RENESAS TECHNICAL UPDATE

Product Category	MPU/MCU		Document No.	TN-RL*-A070A/E	Rev.	1.00
Title	Precaution of using SNOOZE mode		Information Category	Technical Notification		
Applicable Product	RL78/I1C R5F10Nxx	Lot No.	Reference Document	RL78/I1C User's Manual: Hardware Rev. 1.00 R01UH0587EJ0100 (May. 2016)		
		All lot

Figure 26 - 6 When the Interrupt Request Signal is not Generated in the SNOOZE Mode

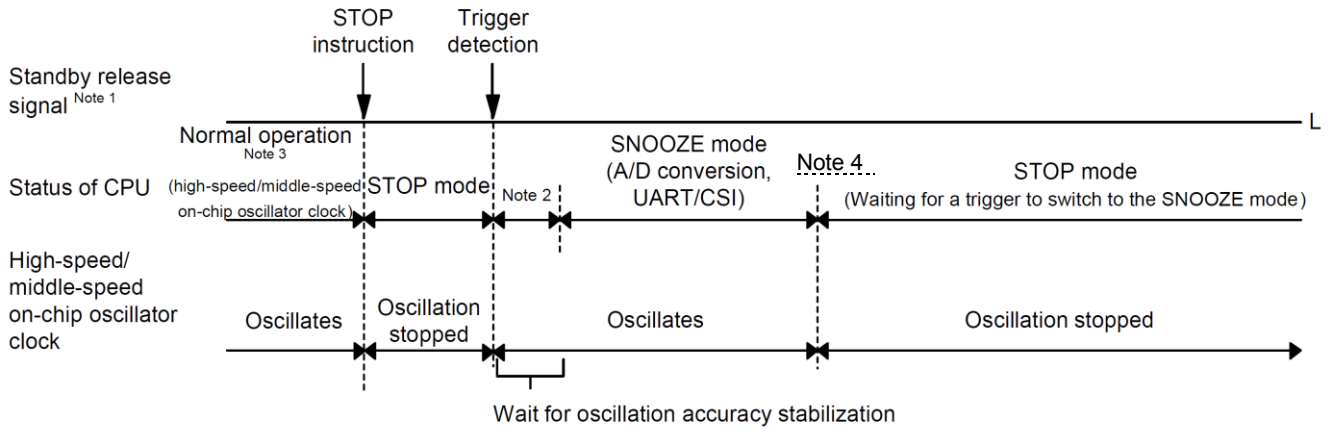
Addition of note when an interrupt Request Signal is Generated immediately after SNOOZE Mode transitions to STOP mode. To add a note 4 to timing chart in "(3) Timing diagram when the interrupt request signal is not generated in the SNOOZE mode" on page 930 section 26, Standby function in the User's manual.

- Note 1.** For details of the standby release signal, see **Figure 24 - 1 Basic Configuration of Interrupt Function**.
- Note 2.** Transition time from STOP mode to SNOOZE mode
- Note 3.** Enable the SNOOZE mode (AWC = 1 or SWC = 1) immediately before switching to the STOP mode.
- Note 4.** If a standby release signal is generated in response to an interrupt from a peripheral function which is not set to operate in the SNOOZE mode during a transition of state from SNOOZE mode to STOP mode, the high-speed on-chip oscillator clock may run slowly for up to 15μs from when the CPU starts to operate. If the clock frequency accuracy specified in the electrical characteristics is required immediately after release from standby, wait for the number of cycles at the actual CPU clock frequency that is equivalent to 15μs.
